Countries: CANADA, UNITED STATES **Document ID:** IK1201440
Availability: ISIS, Fleet!ISIS, IsSIR **Revision:** 2
Major System: ENGINES **Created:** 8/25/2019
Current Language: English **Last Modified:** 6/1/2021
Other Languages: NONE **Author:** Greg Scheff
Viewed: 597

Title: A26 Fuel Delivery Pressure Sensor (FDP) and Harness Pigtail Eliminated

Applies To: All A26 Engines

Figure #1: Engine Mounted Fuel Filter Housing

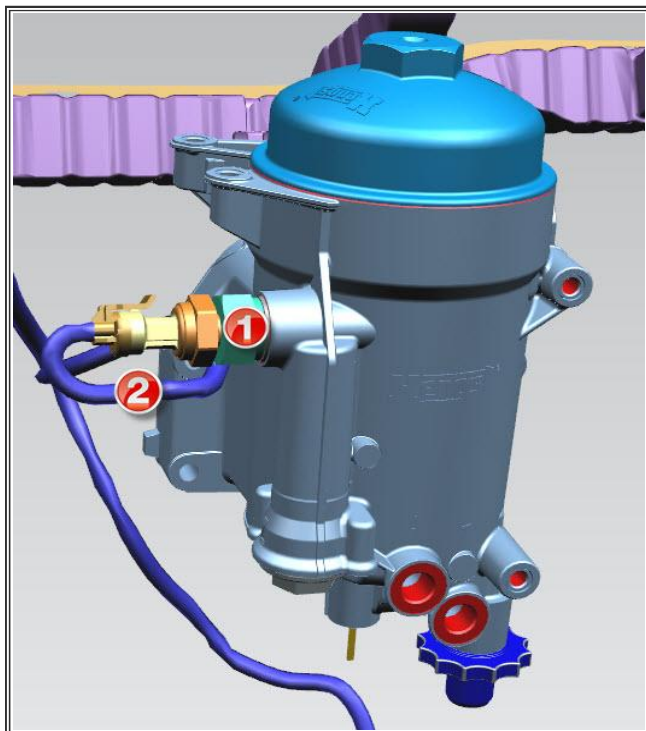
This document will explain the removal of the fuel delivery pressure sensor and harness pigtail on the A26 engine. The early built A26 engines had the fuel delivery pressure sensor installed in the engine mounted fuel filter housing (Figure #1) however, the ECM never monitored the signal from it. Later the sensor was removed, the port was plugged, and the engine harness was modified to remove the pigtail and the connector for it.

Questions from the field have come up while installing a replacement engine harness. Some of the C92 engine harnesses may come through parts when you are replacing a harness on an engine that does not have a FDP sensor installed.

IT IS ACCEPTABLE to install a C92 harness on a newer engine not equipped with the FDP sensor.

- The unused pigtail (Figure #1 item 2) and connector for the FDP sensor can simply be tied off and tucked out of the way OR
- The pigtail (Figure #1 item 2) can be cut off, and apply heat shrink tubing at the wire ends
- The wiring for those circuits to the ECM are not used
